# CITY OF ALBUQUERQUE

RE: **Lot 2 Block 8 Unit 5 SAD 227**  
**Volcano Cliffs**  
**6219 Keyenta Rd. NW**  
**Grading and Drainage Plan**  
**Engineers Stamp Date 12/8/2020 (E10D093)**  
**Pad Certification Date 3/29/2021**

Based upon the information provided in your submittal received 3/30/2021, this plan is approved for Building Permit.

ENGINEER'S SEAL  12/28/20 DAVID SOULE P.E. #14522	LOT 2 BLK 8 UN 5 VC 6219 KEYENTA PLACE NW	DRAWN BY DEM
	GRADING AND DRAINAGE PLAN  1606 CENTRAL AVENUE SE SUITE 201 ALBUQUERQUE, NM 87106 (505) 872-0999	DATE 12-23-20 LOT 2 BLK 8 UN 5 VC.DWG
		SHEET # C1
		JOB #

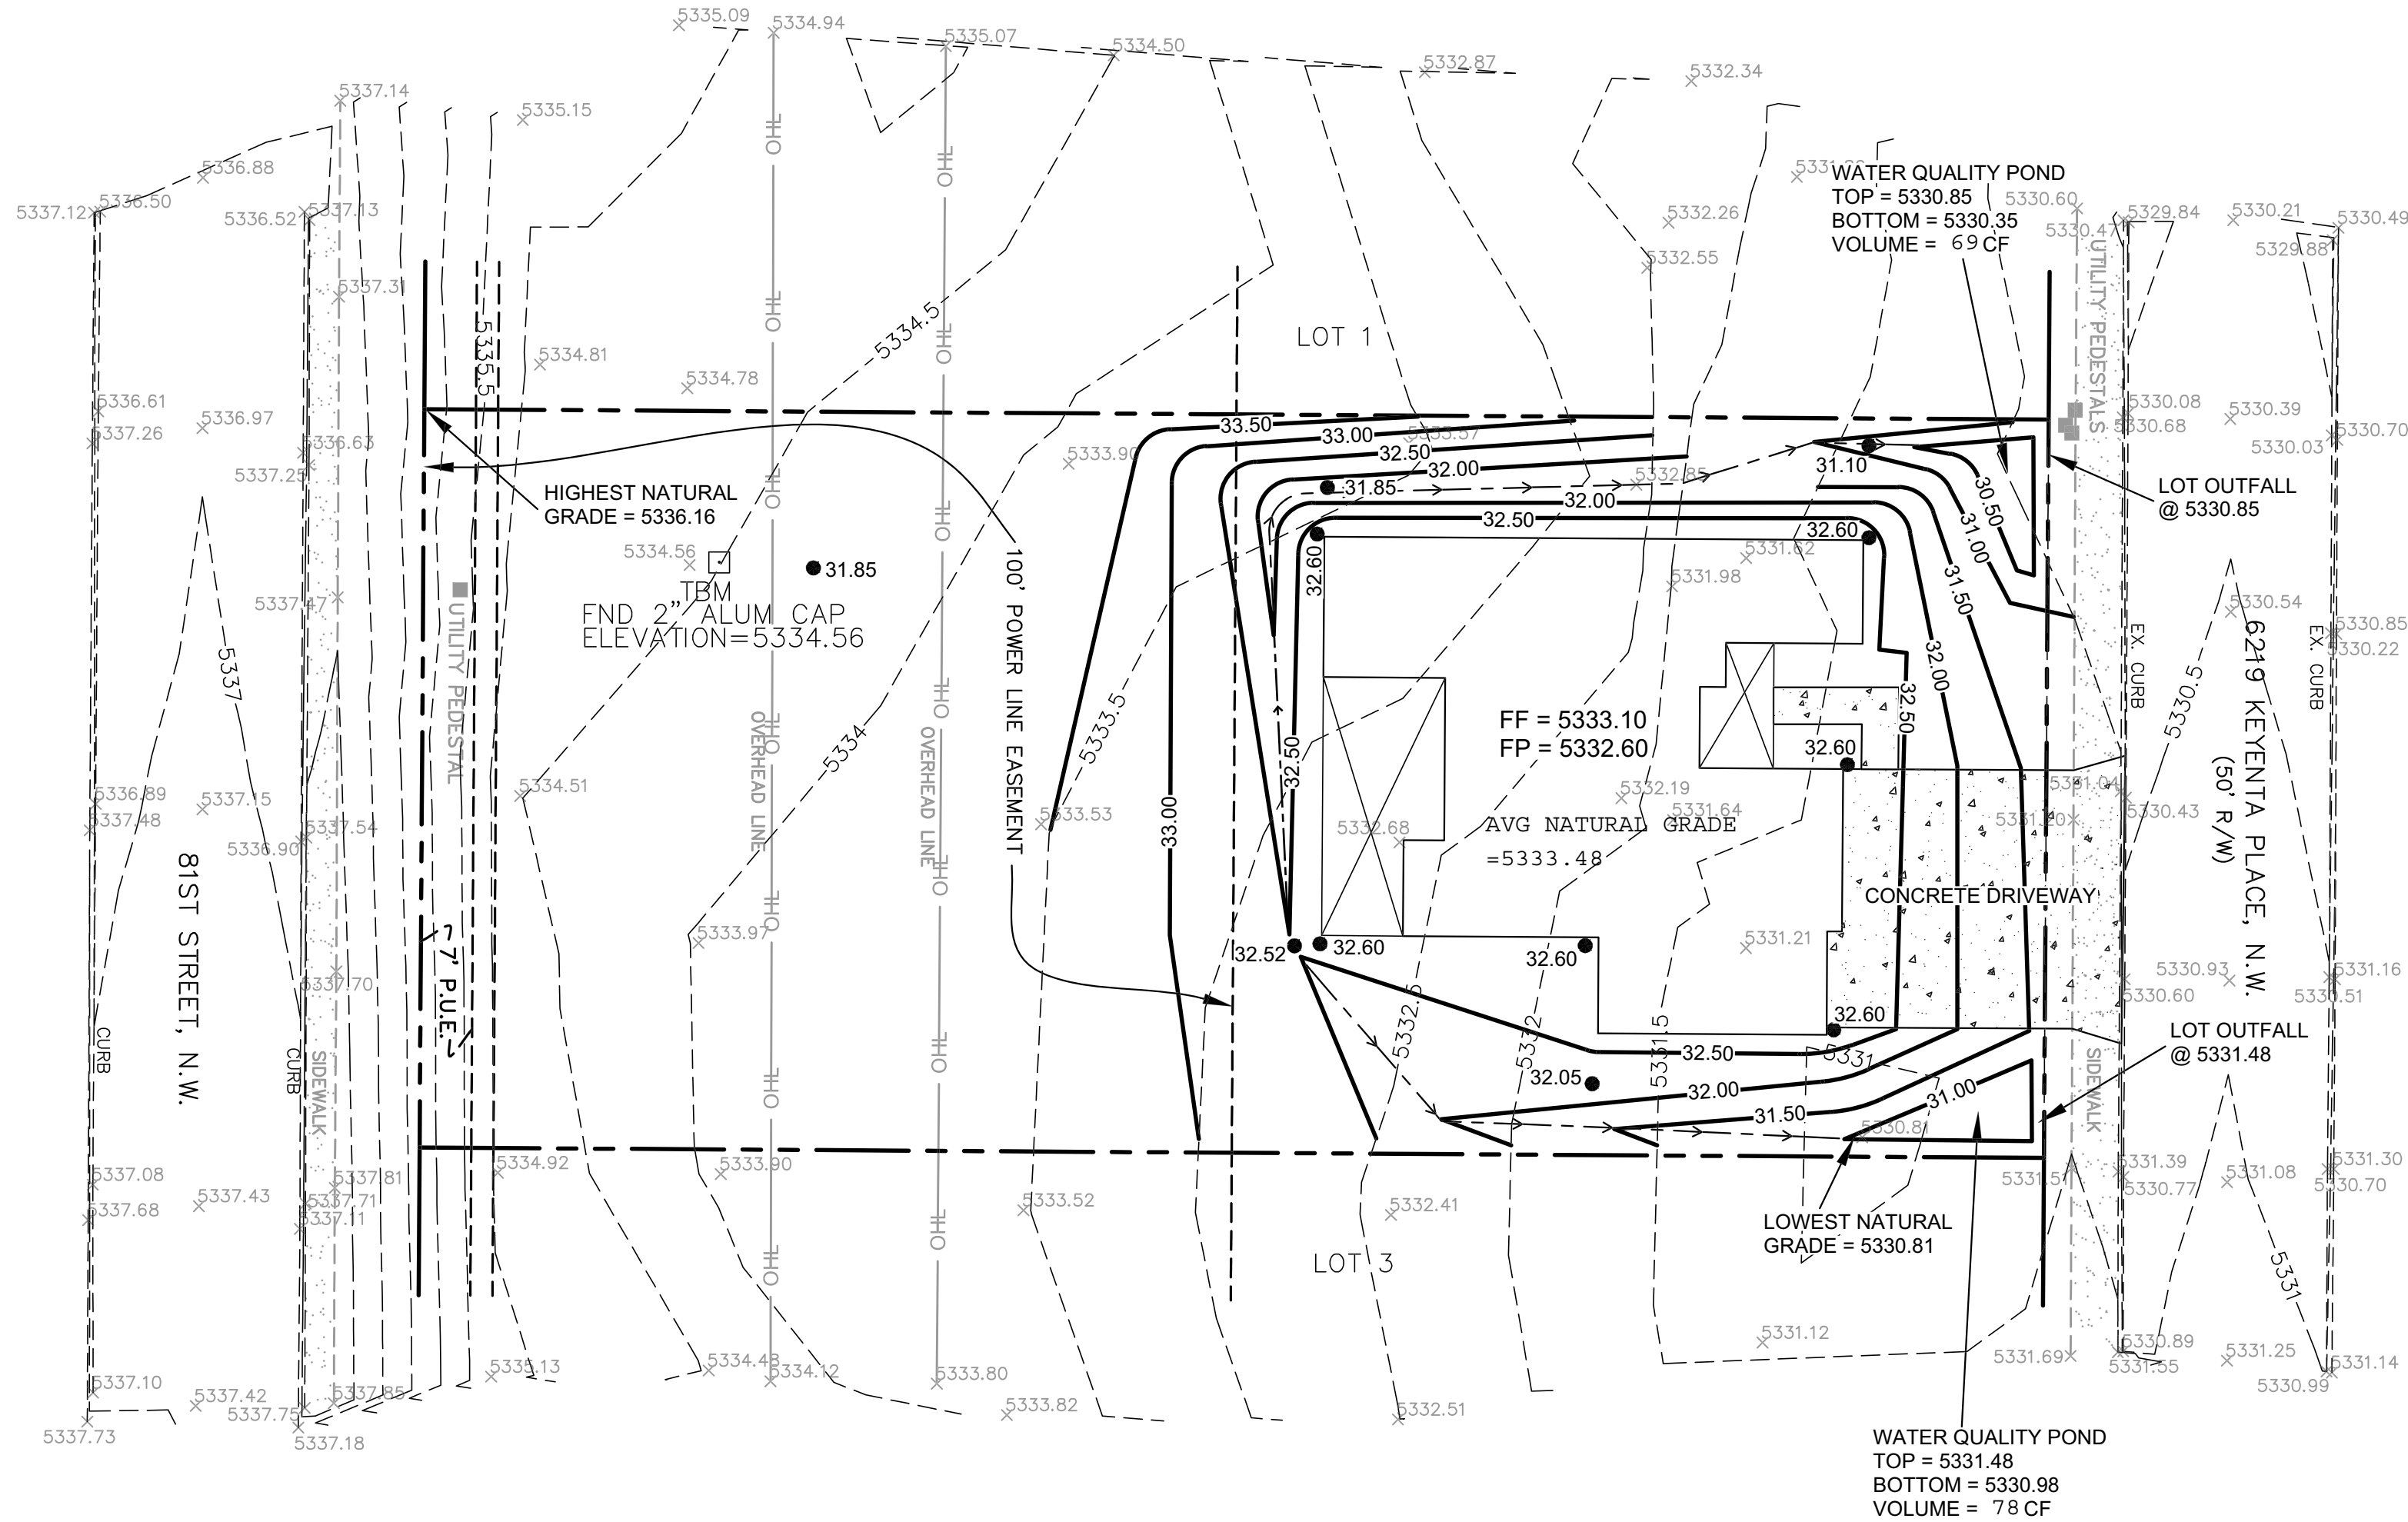
**Reiterate to the Owner/Contractor that a separate permit for a garden/retaining wall must be obtained, with the approved G&D plan.**

Prior to Certificate of Occupancy release, Engineer Certification per the DPM checklist of this plan will be required.
